STAFF REPORT ADDENDUM

APPLICATION SE 2015-SP-023 &
2232-S15-5

APPLICANT: Cellco Partnership d/b/a Verizon Wireless;
Little League Inc. Fairfax

PROPOSAL: The applicants have filed for review by the
Planning Commission to determine whether
the proposed 164 foot telecommunications
facility and related ground structures satisfy the
criteria of location, character and extent
pursuant to Sect. 15.2-2232 of the Code of
Virginia, and requests Special Exception
approval to construct the proposed
telecommunication facility on the property.

Figure 1- Revised SE Plan

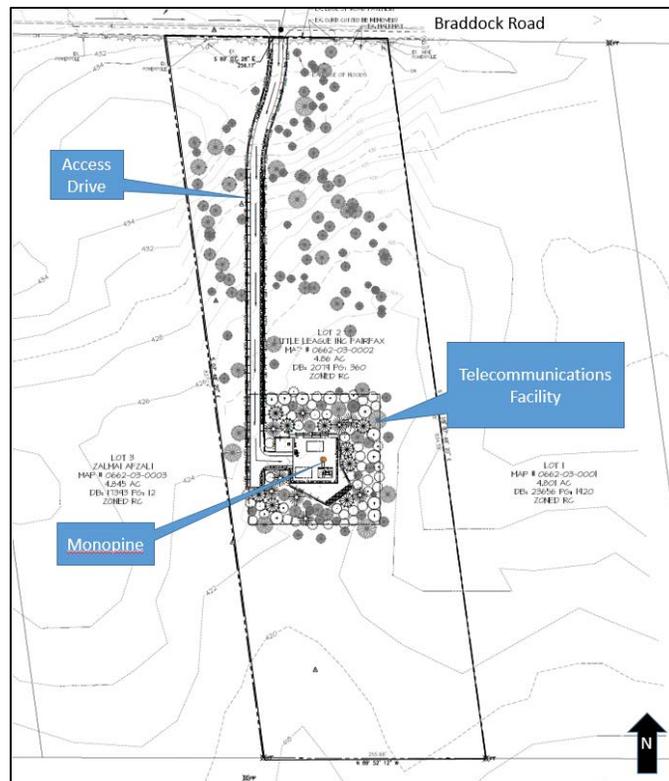
On January 21, 2016, the Planning Commission held a public hearing on this case. The Planning Commission directed applicants to address community concerns related to visibility. The applicants have updated the Special Exception (SE) Plat with the following changes: (as shown in Figures 1 and 2):

- Provision of a new curb cut and addition of a dog leg design in the access drive layout to reduce the visual impact of the telecommunications compound from Braddock Road
- Increased the setback of the tower location from Braddock Road from 240 feet to be approximately 480 feet
- Changed the design of telecommunications facility from a monopole to a stealth tree pole (aka monopine)
- Revision of the Tree Preservation Plan to reflect the changes to the revised design
- Revision of the Stormwater Management Plan to reflect the changes in the revised design

The applicants revised their SE Plat to reflect concerns from neighborhood residents about the proposed visibility of the facility. The applicant has increased the setback from Braddock Road, changed the design from a monopole to a tree pole (monopine) and reoriented the access road. As a result the applicant updated their tree preservation plan and the storm water management plan, which has also been reviewed by appropriate county staff. The remainder of the SE application remains unchanged.
